CNP UNITS 1 AND 2 IMPROVED TECHNICAL SPECIFICATIONS CONVERSION

ITS CHAPTER 4.0 DESIGN FEATURES

ITS Chapter 4.0, Design Features

**Current Technical Specification (CTS) Markup
and Discussion of Changes (DOCs)**

Figure 4.1-1 (Page 1 of 1)
Site and Exclusion Area Boundaries

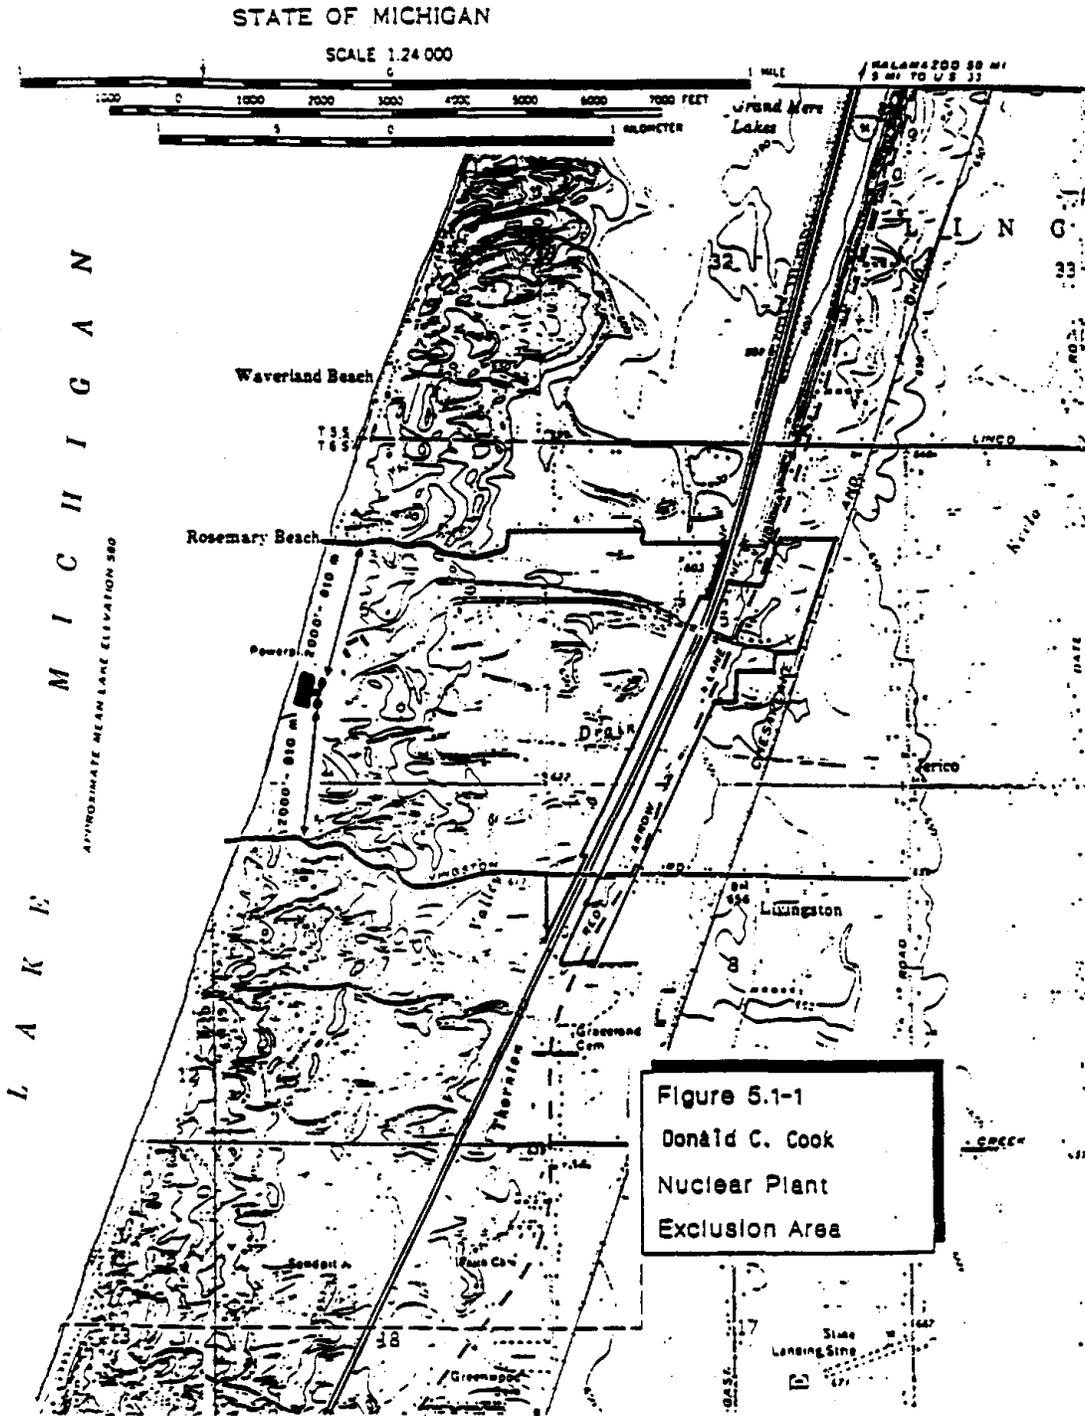
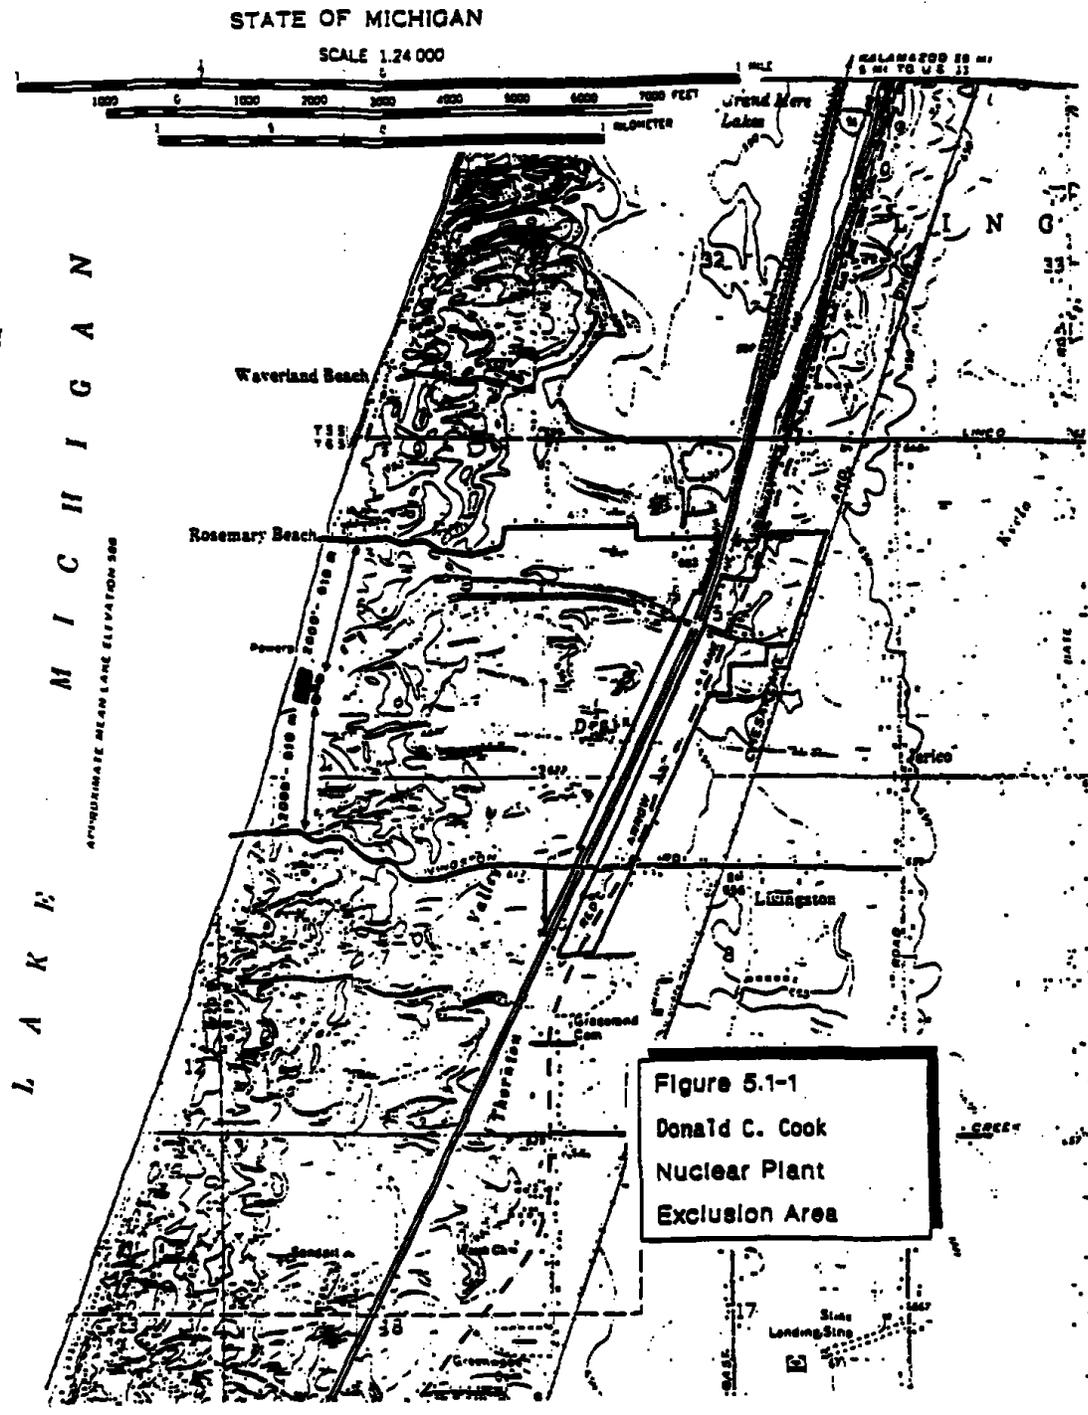
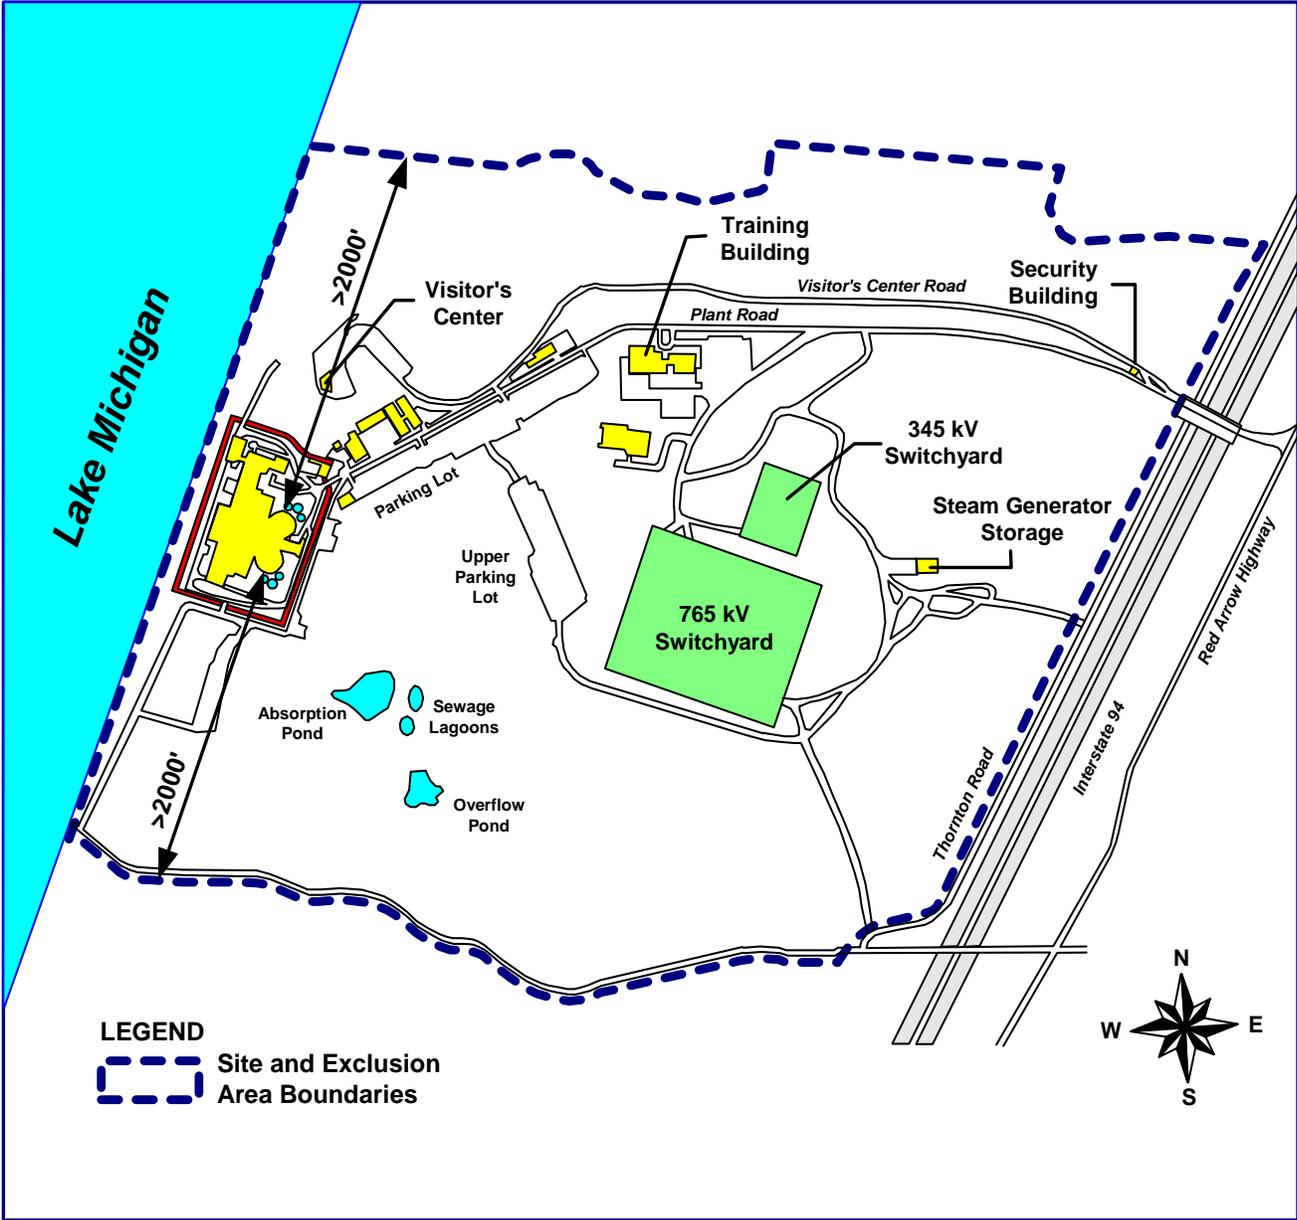
- A.2 CTS 5.1.2 states "The low population zone shall be as shown in Figure 5.1-2." CTS Figure 5.1-2 provides a map depicting the low population zone. ITS 4.1.2 provides a description of the low population zone; a figure is not provided. This changes the CTS by providing a word description of the low population zone instead of a map.

The site area and exclusion area boundaries are as shown in Figure 4.1-1.

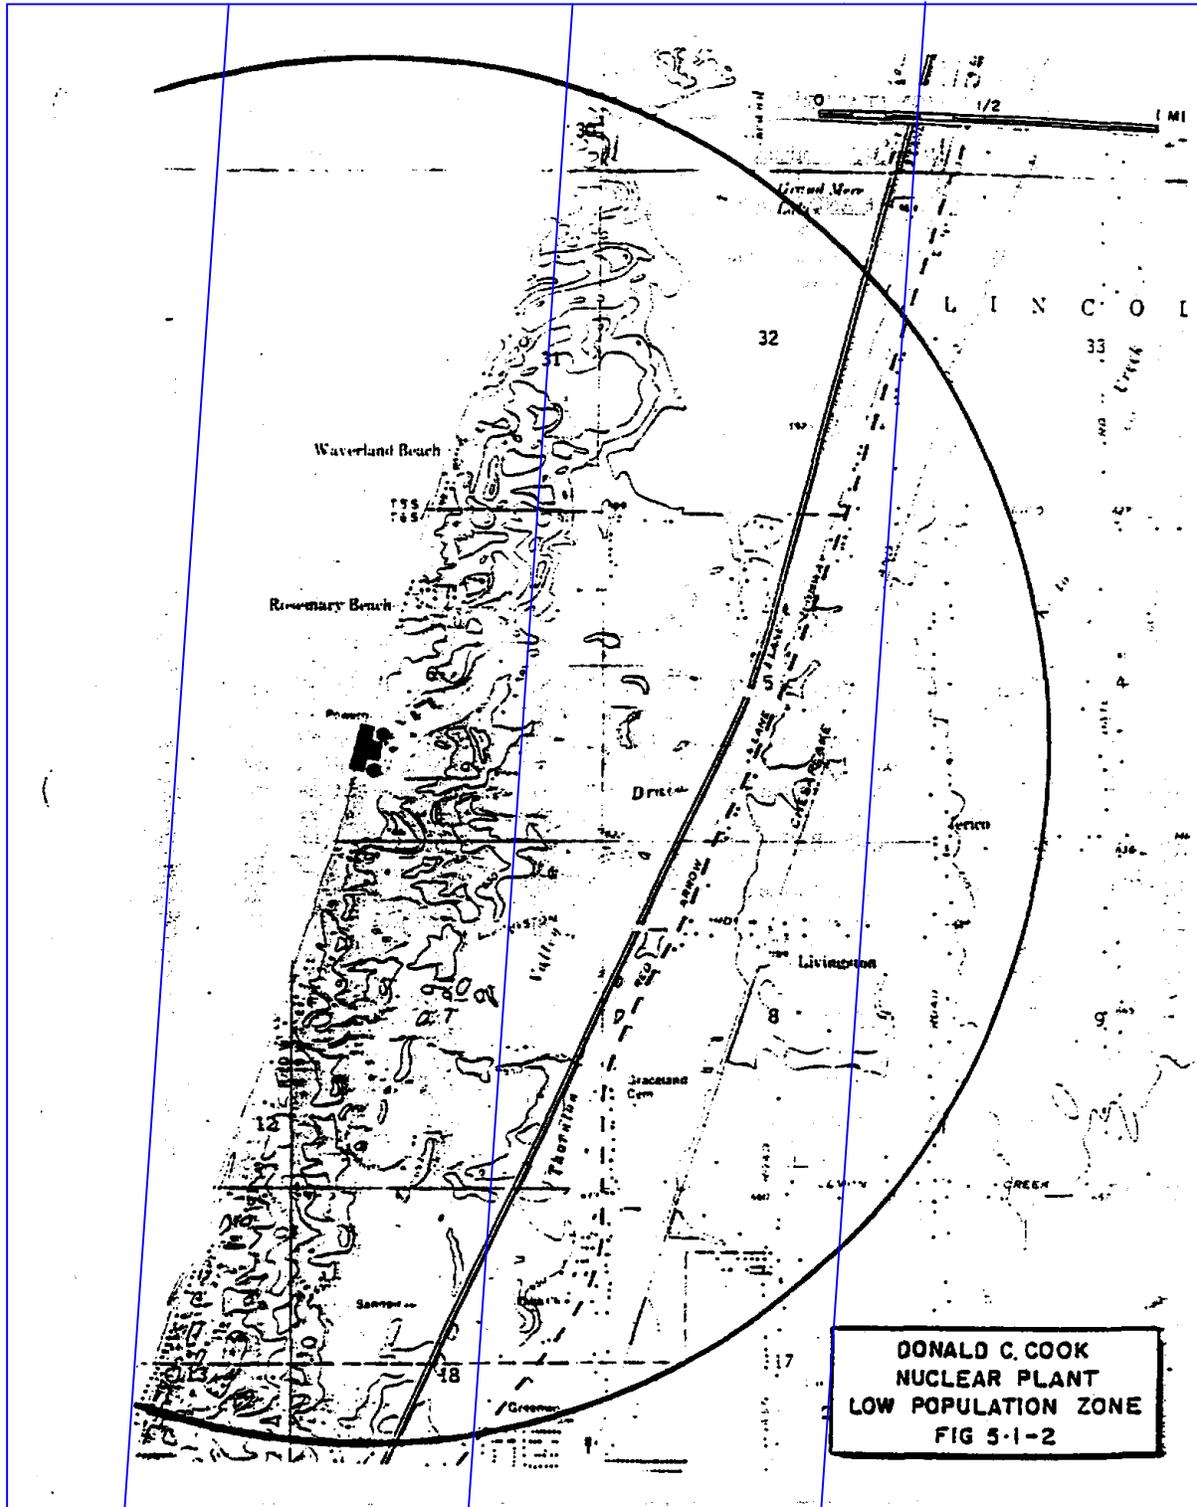
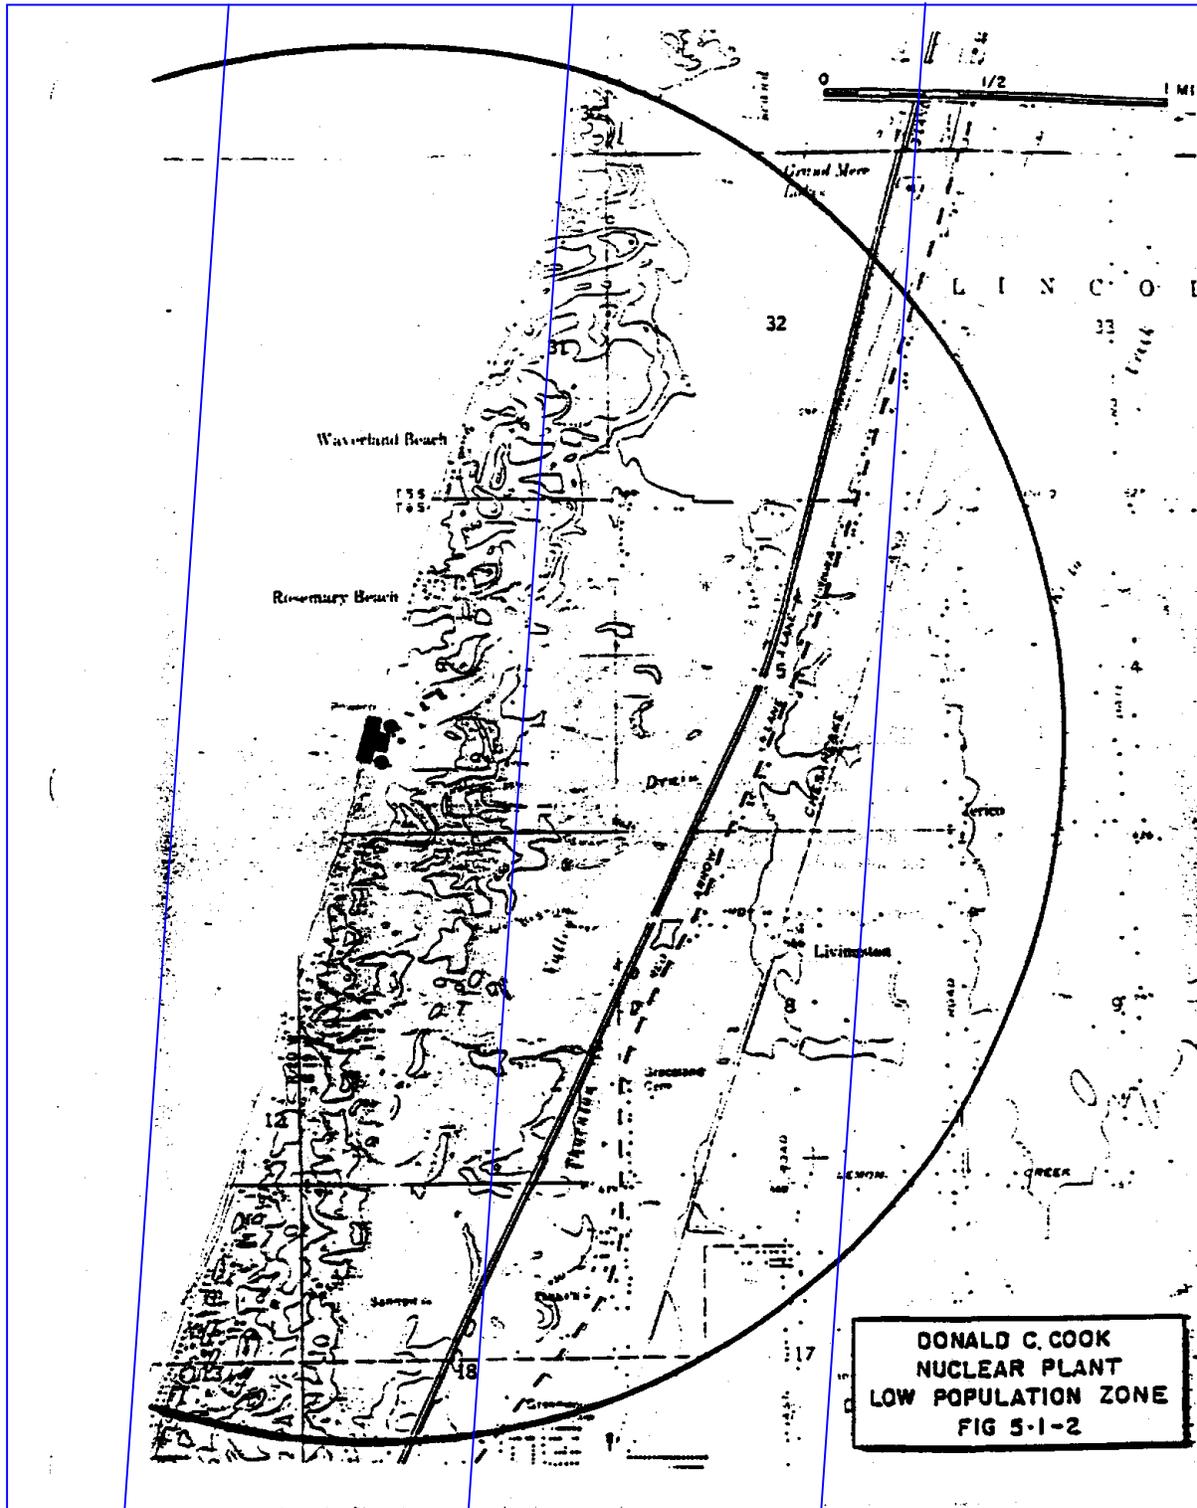
5.1.2 The low population zone shall be as shown in Figure 5.1-2.

This change is acceptable since it does not change the current requirements. A description is provided consistent with the current map in the figure. This change is designated as administrative because it does not result in a technical change to the Technical Specifications.

The low population zone is all the land within a circle centered on the reactor containment structures and a radius of 2 miles.

Figure 3.3-2: Interim Storage Pattern (Checkerboard)

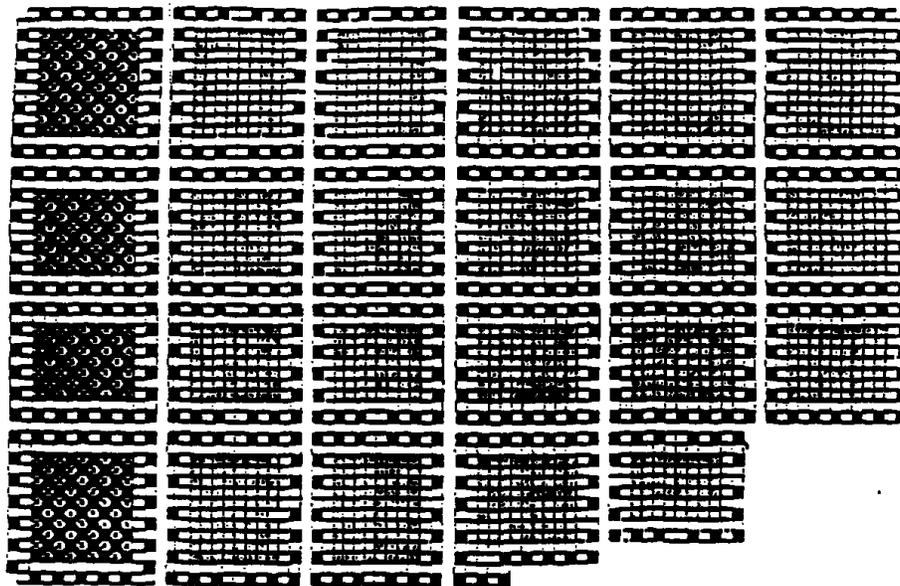
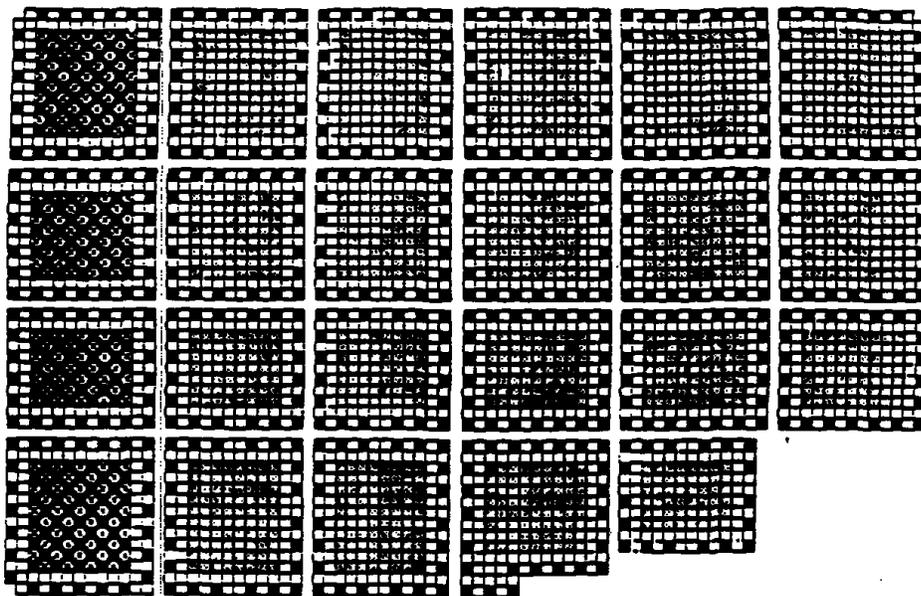
A.3

- A.3 CTS Figures 5.6-1 and 5.6-2 provide drawings that depict the various regions of the spent fuel storage pool racks for a normal storage pattern (mixed three zone) and for an interim storage pattern (checkerboard). The key at the bottom of the figures identifies the total number of cells for the various regions. The CTS Figure 5.6-1 key identifies, in part, that there are 1415 Region 2 cells and 1694 Region 3 cells, and the CTS Figure 5.6-2 key identifies, in part, that there are 1415 Region 2 cells and 1379 Region 3 cells. The ITS Figure 4.3-1 key identifies that there are 1439 Region 2 cells and 1670 Region 3 cells, and the ITS Figure 4.3-2 key identifies that there are 1439 Region 2 cells and 1355 Region 3 cells. This changes the keys to clearly identify the actual number of cells depicted in each region.

This change is acceptable since it does not change the current requirements. The number of cells listed in the keys for the ITS Figures is consistent with the actual number of cells depicted by the Figures. This change is considered administrative because it does not result in a technical change to the Technical Specifications.
